DEVELOPMENT ASSESSMENT REPORT	
Application No.	DA/2021/1078
Address	14 Leys Avenue LILYFIELD NSW 2040
Proposal	Alterations and additions to an existing dwelling, including lower ground and first floor extension, internal reconfiguration of space, swimming pool, detached studio, removal of tree, landscaping and associated works.
Date of Lodgement	2 November 2021
Applicant	Mr Adrian R Wilson
Owner	Mr Adrian R Wilson Ms Tiffany L Glover
Number of Submissions	Initial: 16
Value of works	\$750,267.00
Reason for determination at Planning Panel	Clause 4.6 variation exceeds 10% Number of submissions
Main Issues	Landscaped Area Solar Access Distinctive Neighbourhood Building Location Zone Side Boundary Setbacks
Recommendation	Approved with Conditions
Attachment A	Recommended conditions of consent
Attachment B	Plans of proposed development
Attachment C	Clause 4.6 Exception to Development Standards

1. Executive Summary

Project: 14 Lays Ave Lilyfield NSW 2040	Date: 12/10/2021
	Drawing: Proposed Site & Landscape Plan	Drawing No: 42.04A
Client: Adrian Wilson & Tiffany Clever		Scale: 1:100

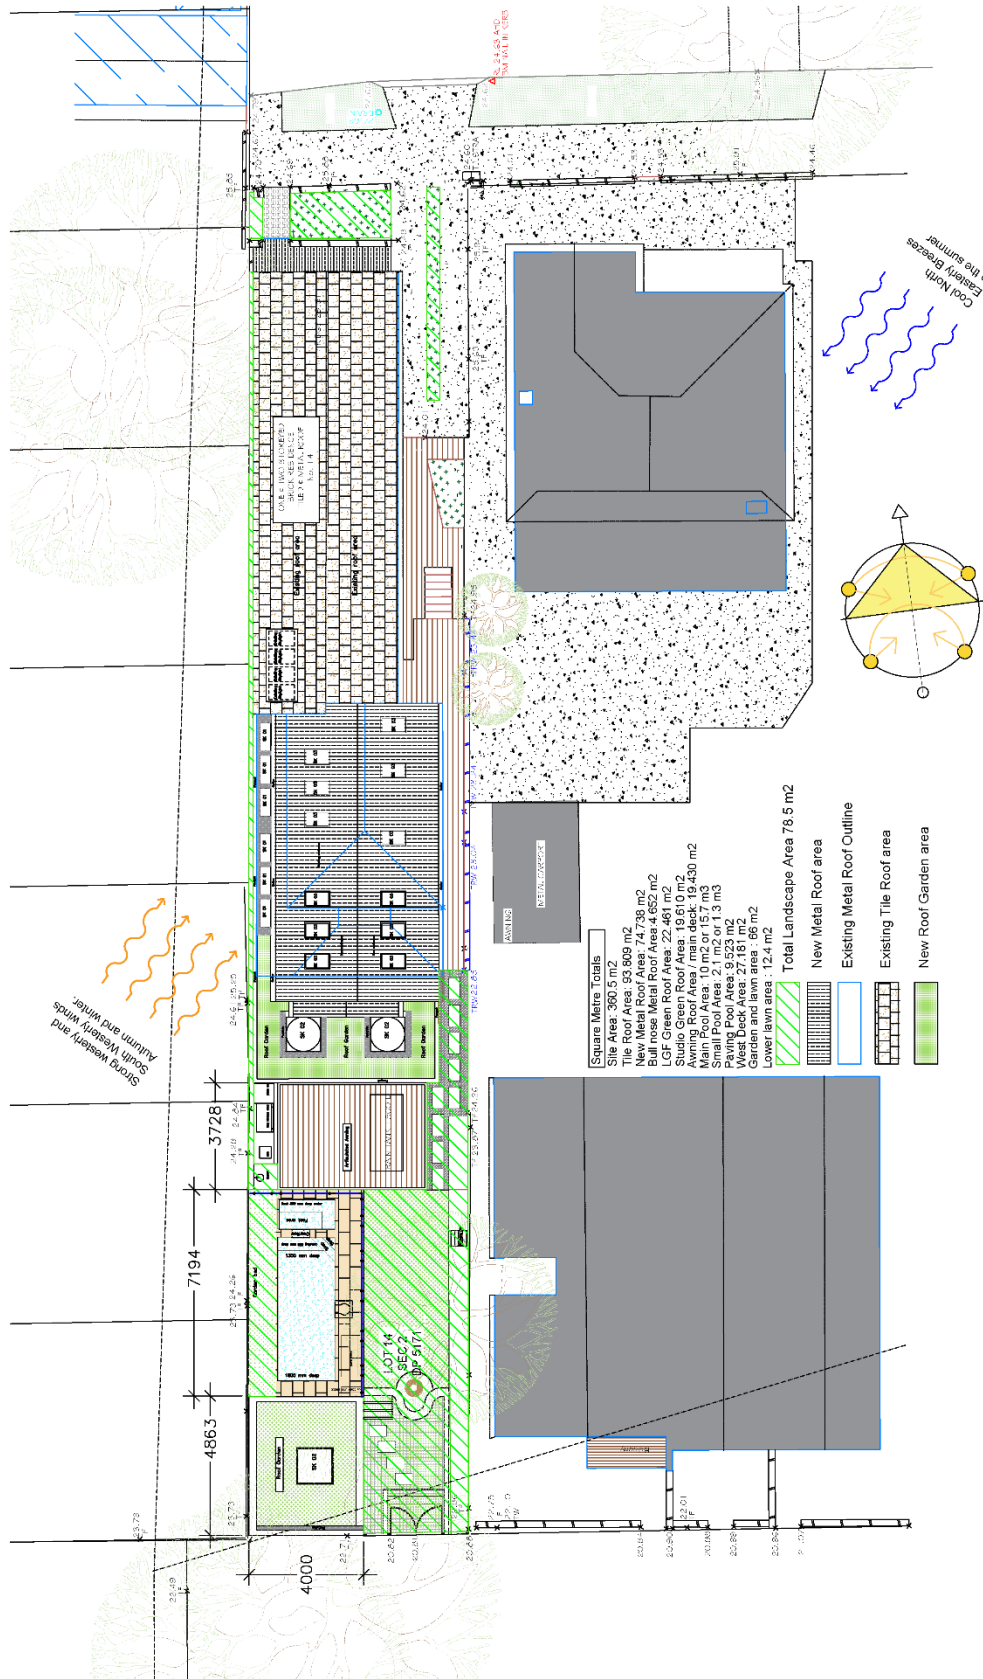
It is considered that the application could provide additional landscaping beyond what is existing, thus the written justification to reduce the landscaped area below the existing amount in this instance is not endorsed and it is recommended that a condition of development consent is imposed requiring the paved area and stepping stones located to the east of the proposed studio to be amended with grass/landscaped area.

Further, a condition is recommended to delete the proposed studio, to ensure the proposal is in accordance with the desired future character of the neighbourhood. (It is advised that there is currently a studio located in the rear yard, which appears on the aerial photo to have been constructed in late 2011. The studio does not appear to be Exempt, due to its proximity to the boundary, and there is no other approval registered for it).

- a. The area identified as "paving" on Drawing No. 42.07A and located east of the proposed studio is to be amended to delete the proposed stepping stones and must grassed and/or landscaped area.
- b. The proposed studio located within the rear yard is to be deleted.
- c. The extent of the western side boundary fence proposed to be raised in height shall be no higher than RL 24.28.
